August 25, 2017

RE: **Lot 23-A Block 5 Unit 5 Volcano Cliffs SAD 227**
8004 Victoria Dr NW
Grading and Drainage Plan
Engineers Stamp Date 8/23/17 (D10D033)

James D. Hughes, P.E.
Principal Engineer, Hydrology
Planning Department

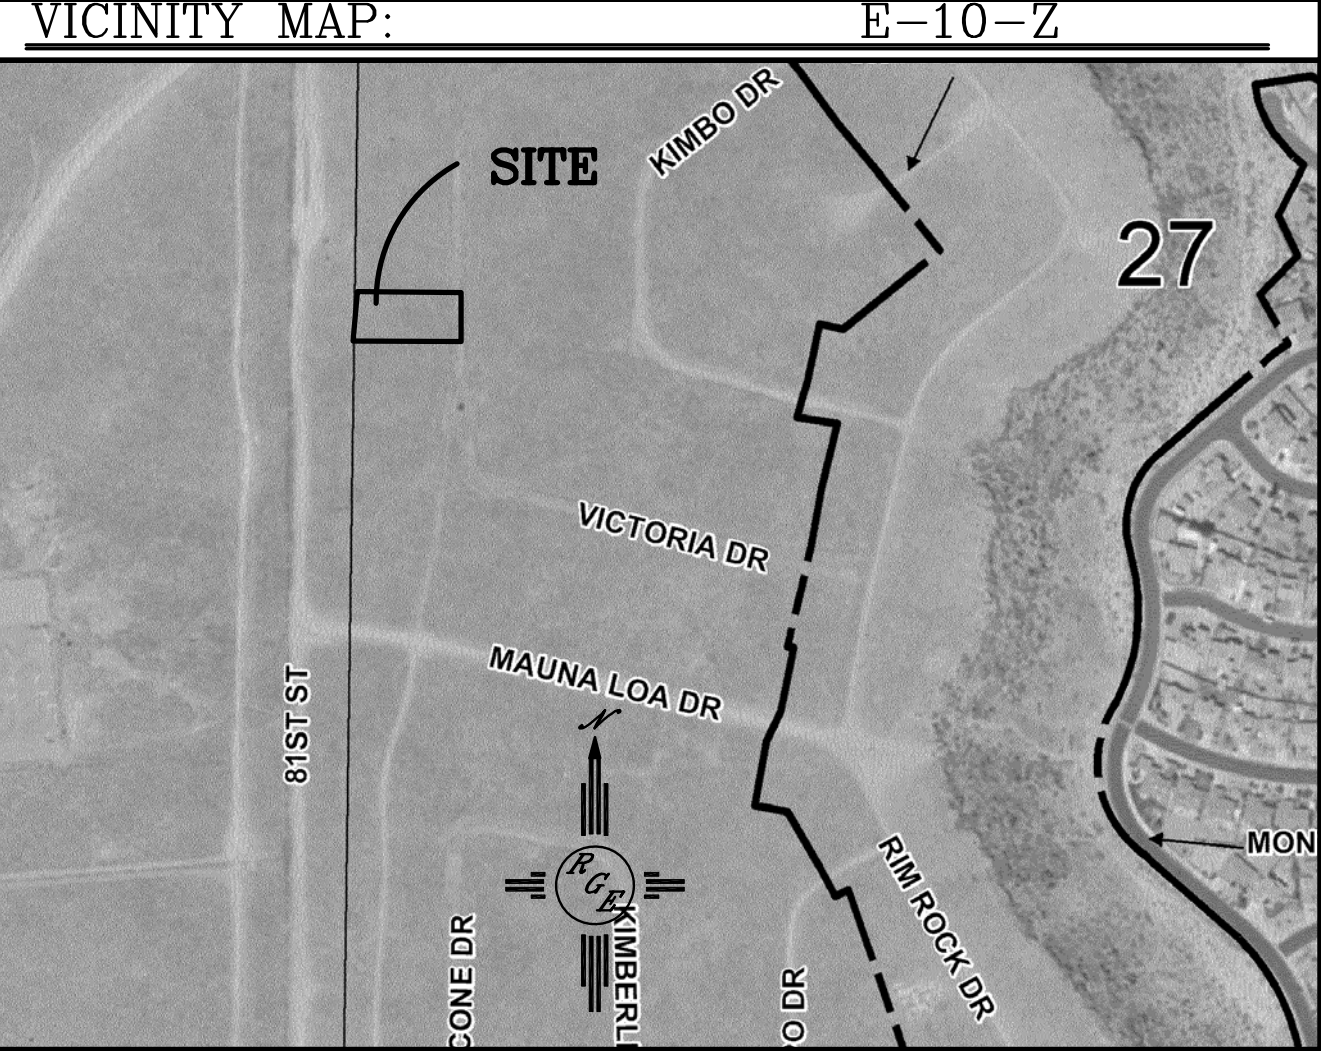
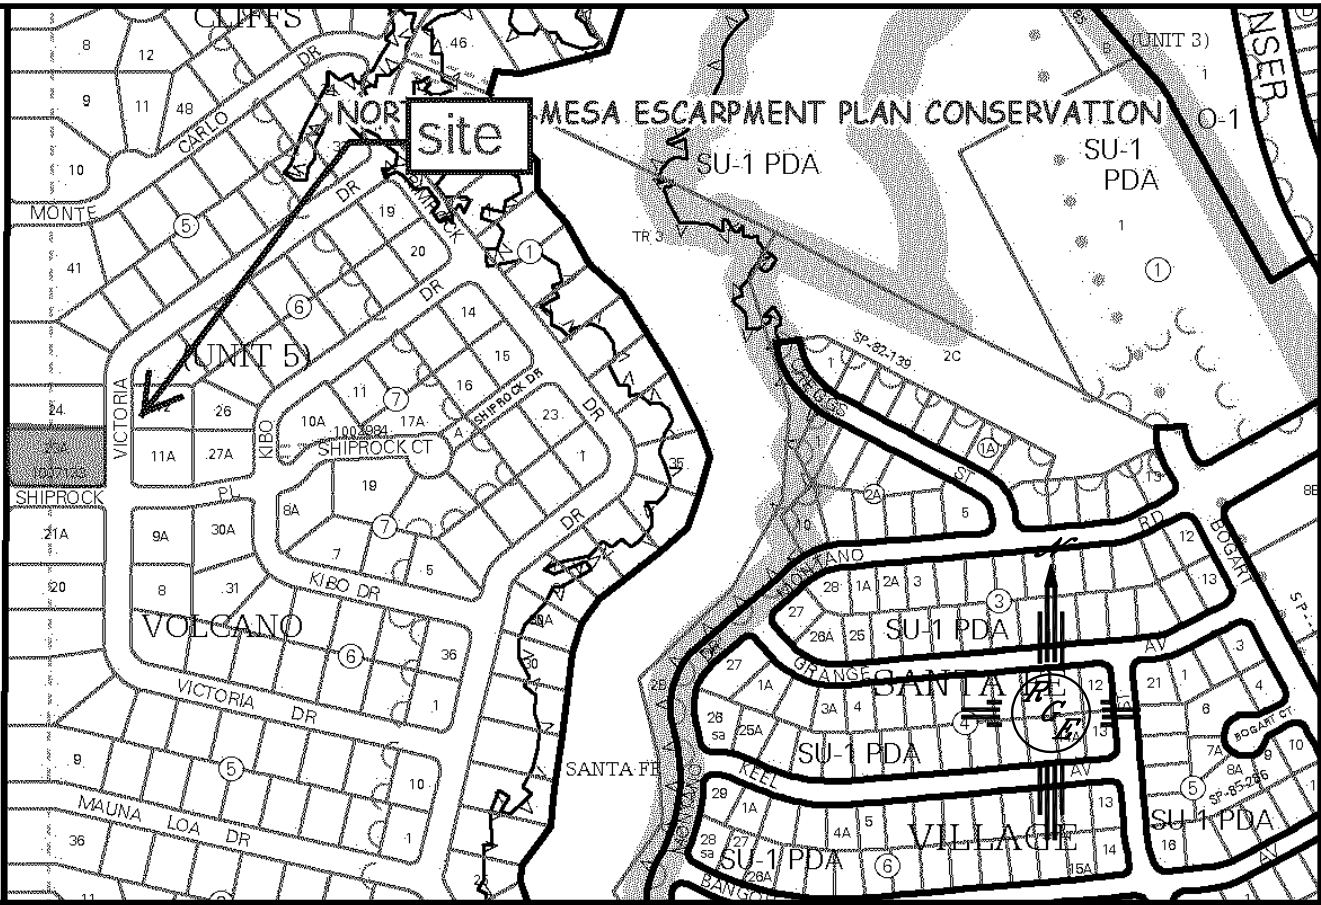
Based upon the information provided in your submittal received 8/23/17, this plan is approved for Grading Permit.

Reiterate to the Owner/Contractor that a separate permit for a garden/retaining wall must be obtained, with the approved G&D plan dated 8/23/17.

Prior to Building permit approval a Pad Certification will be required, provided by the Engineer or a registered Land Surveyor.

Prior to Certificate of Occupancy release, Engineer Certification per the DPM checklist of this plan will be required.
